Modification of the new ICOM HM-36 Microphone

Delivered with IC-7200 and other transceivers

This is a picture of the newer <u>unmodified</u> HM-36.

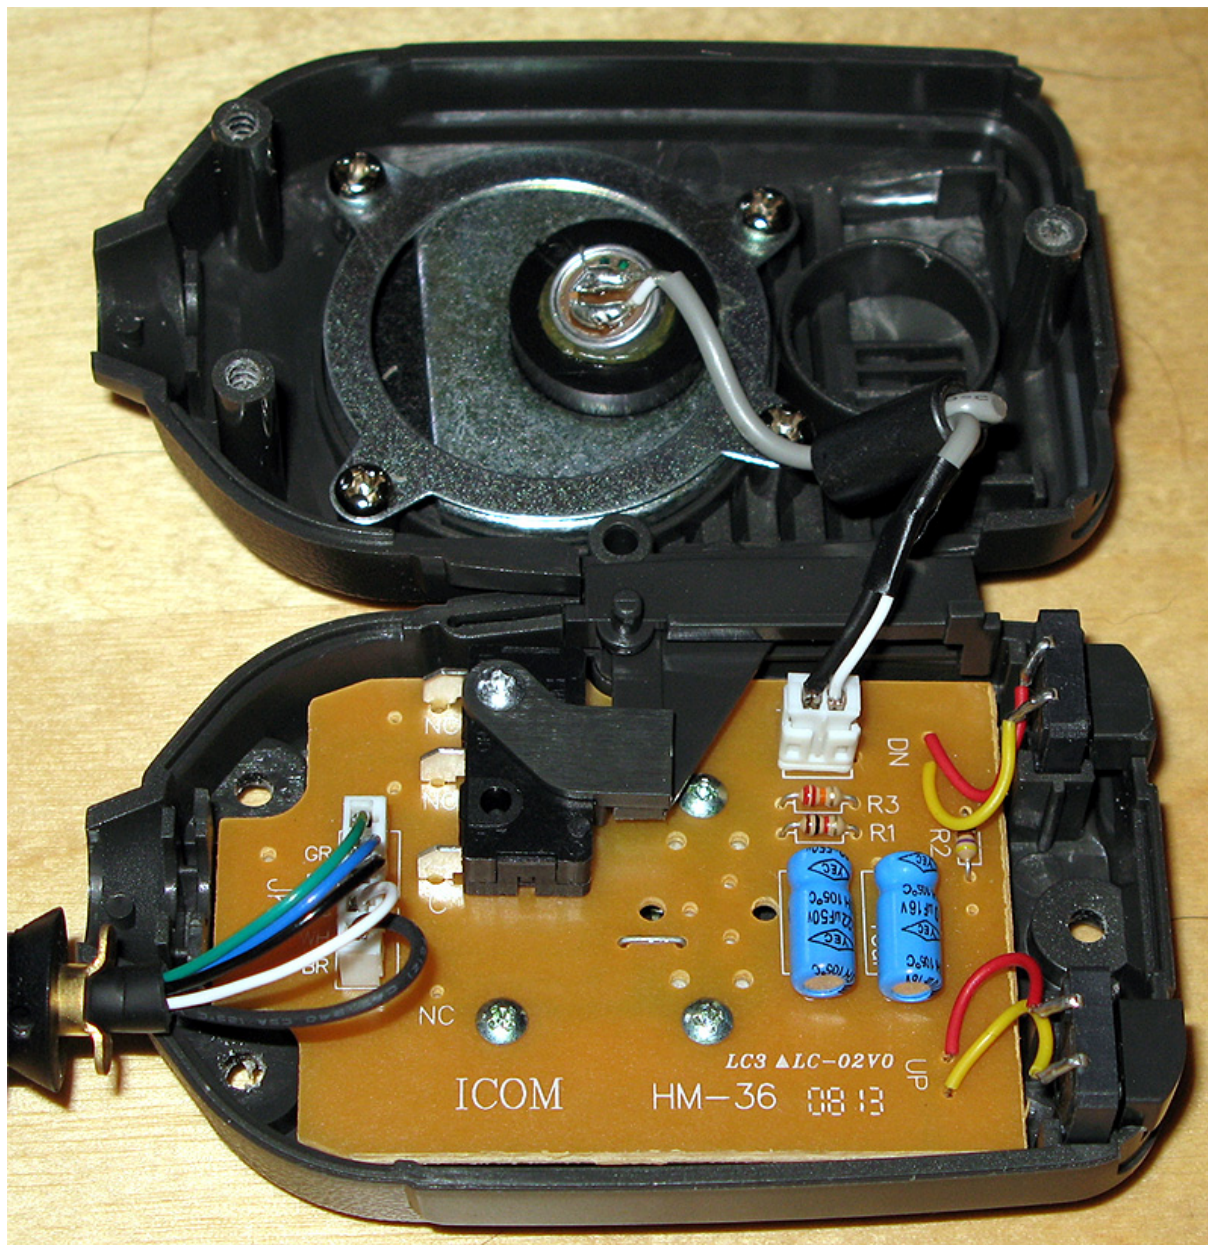
The new HM-36 entered the market at the end of 2007 and beginning of 2008. This new type has too less of the higher frequencies and too much of the low ones.

The new type only have too wires connected to the element. It is simple to modify the new type to sound as the old one.

1. **Remove** R1, 1 kOhm and C2, 10 uF.
2. **Change** C1 from 0.22 uF to 0.01 uF (equal to 10 nF or 10 000 pF)

These components are marked on the circuit board and easy to locate.

The C1 can be replaced with a tantalum or ceramic capacitor.
